September 2019
FL795A
NHTSA #18V-697

Subject: FCCC MT Chassis Ground Cable Studs

Models Affected: Specific Freightliner Custom Chassis MT chassis manufactured September 29, 2017, through June 14, 2018.

Fig. 1, Transmission Shifter Wiring

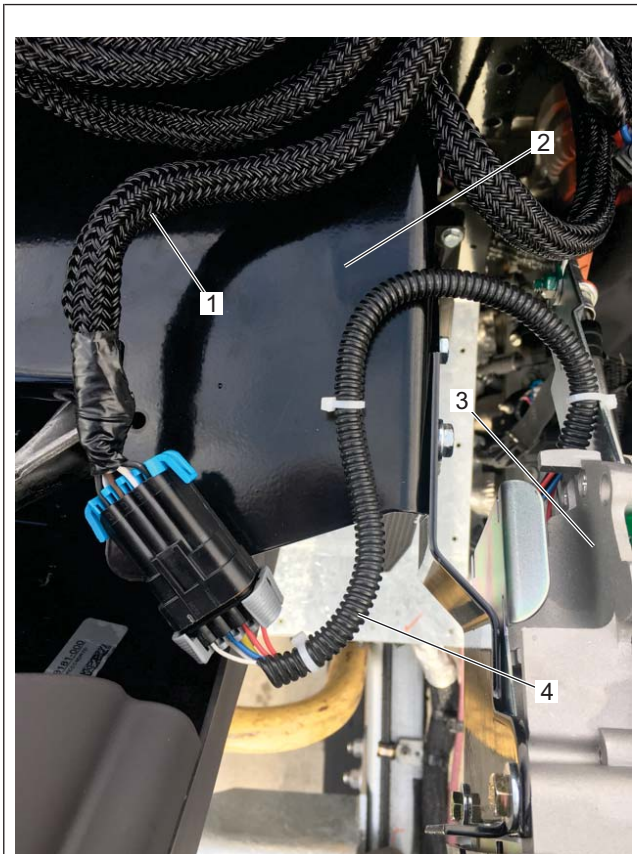
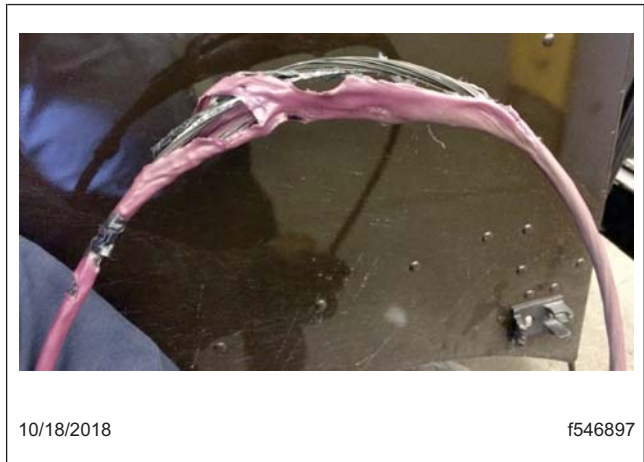
7. Turn off the headlights.
8. Disconnect the negative battery cable.
9. Remove the engine cover.
10. Inspect the wiring going to the transmission shifter for any signs of melting. This can be done by looking up between the operators station and the transmission shifter. See [Fig. 1](#).

11. If there is no backlighting on any dash components, follow normal troubleshooting procedures to repair the issue. If backlighting is present on everything except the transmission shifter, or if harness damage is found, repair the damaged wiring. For damaged wiring on the transmission shifter side, replace the transmission shifter assembly.

Fig. 3, Transmission Shifter Cable, Inside the Vehicle

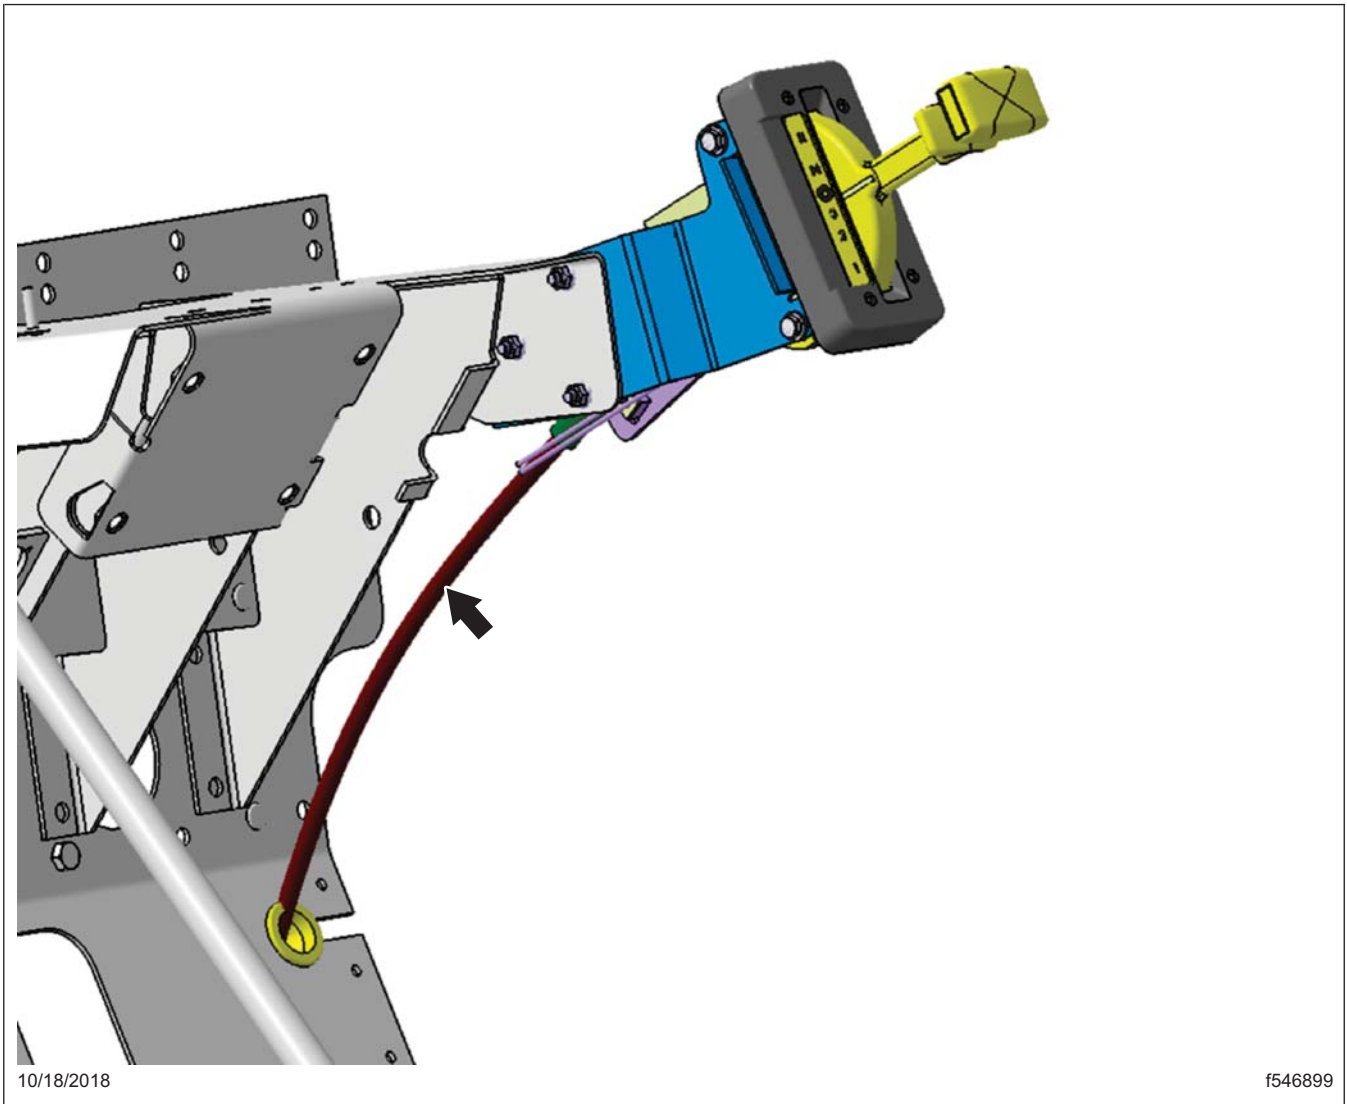
12. Inspect the entire length of the transmission shifter cable for signs of melting or heat damage. See [Fig. 2](#), [Fig. 3](#), and [Fig. 4](#).

13. If the transmission shifter is tight or has heat damage, replace the cable.
14. Using two wrenches, hold the ground stud and remove the locknut that retains the engine ground cable. Discard the nut and washers. See **Fig. 5**.

Fig. 6, Cable Routing, Standard Installation

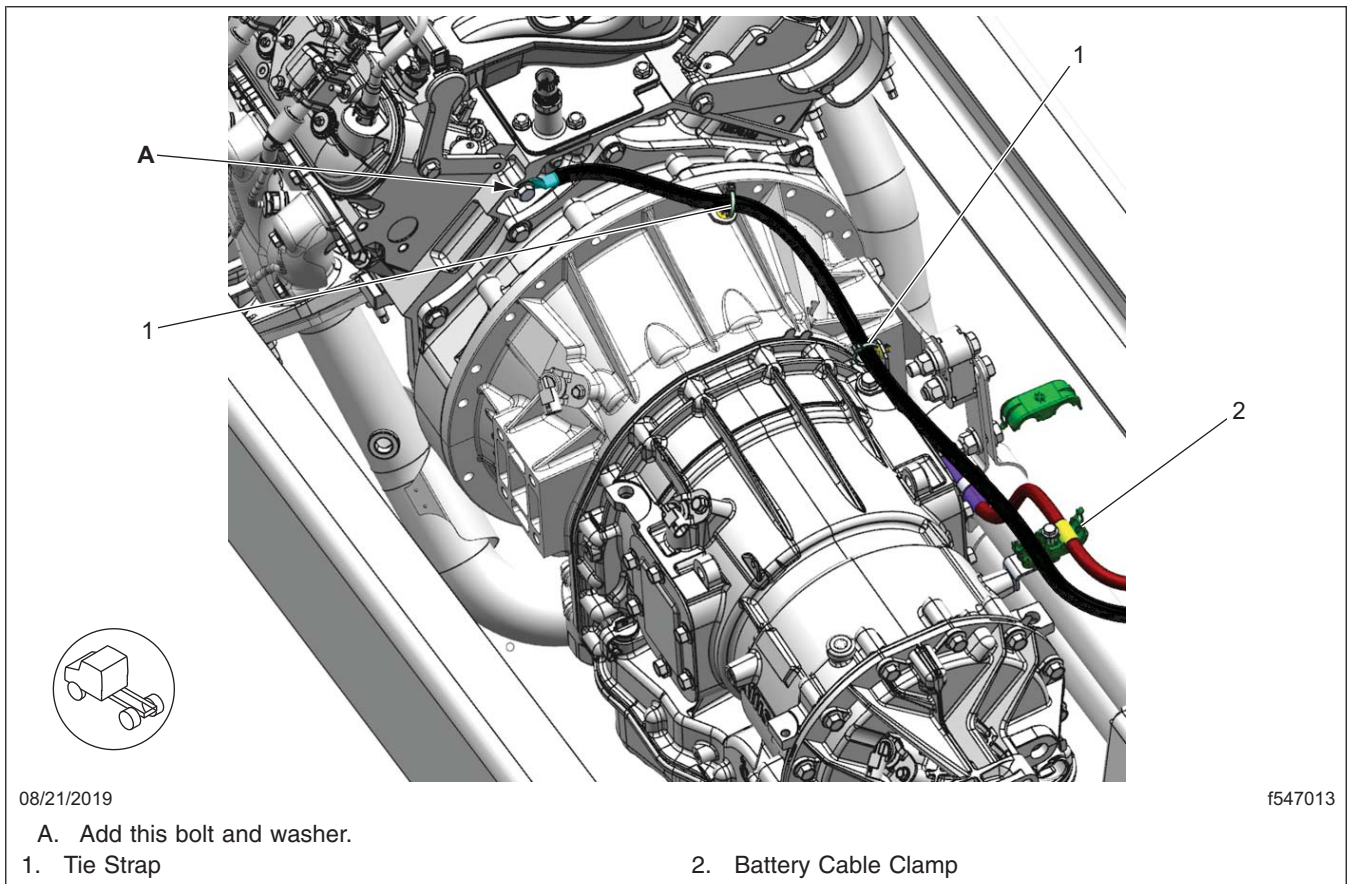
18. Using the new bolt and washer, install the new engine battery ground cable and engine harness ground wire as shown in **Fig. 6** for a standard installation.

Ensure that the cables do not get twisted during installation. Install the new engine battery ground cable on the weld stud of the frame rail with the other ground cables. Tighten the bolt 24 to 29 lbf-ft (33 to 39 N·m).

19. Using new battery cable clamps (off-white in color) and the hardware removed earlier, secure the new engine battery ground cable. Tighten the retaining hardware 60 to 84 lbf-in (678 to 949 N·cm).

Fig. 7, Cable Routing, Vehicle with Telematics

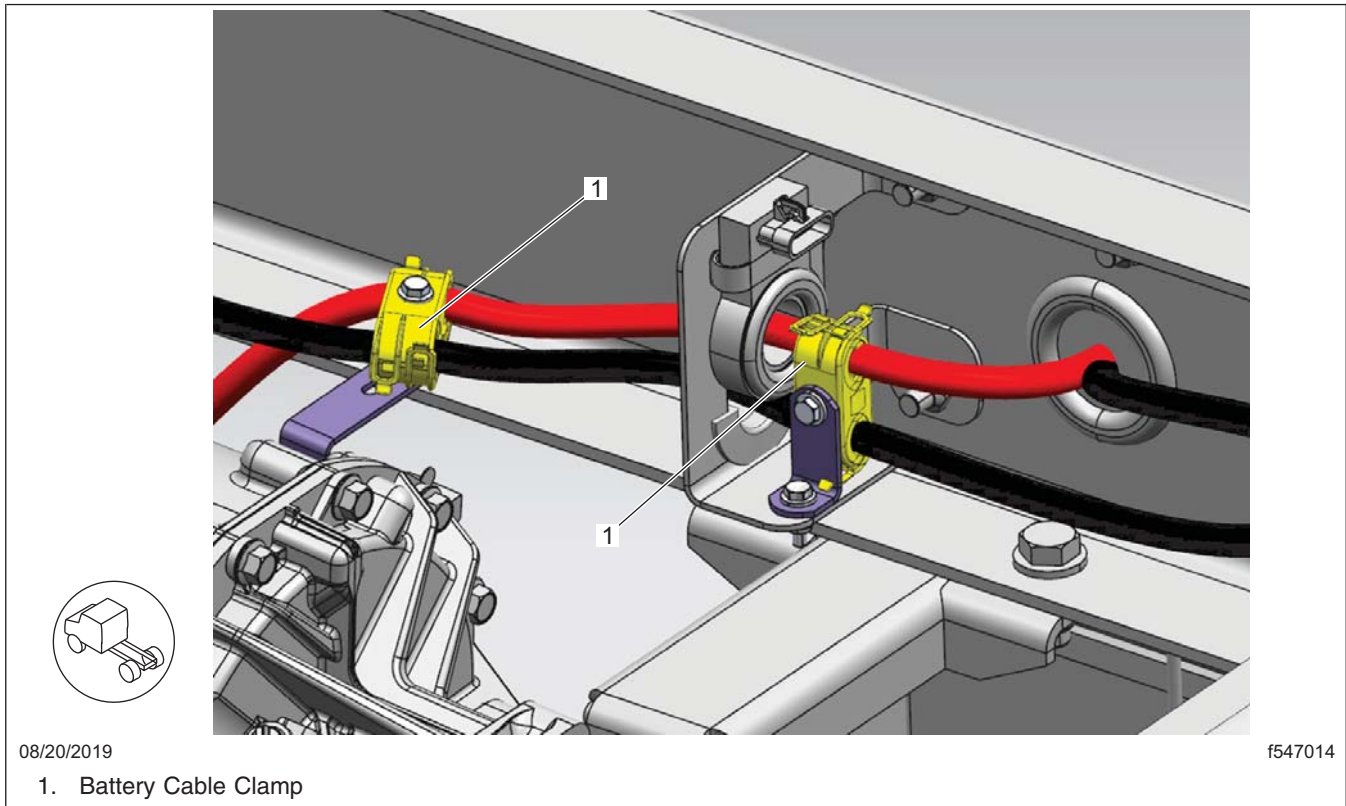
See **Fig. 7** for vehicles equipped with telematics.
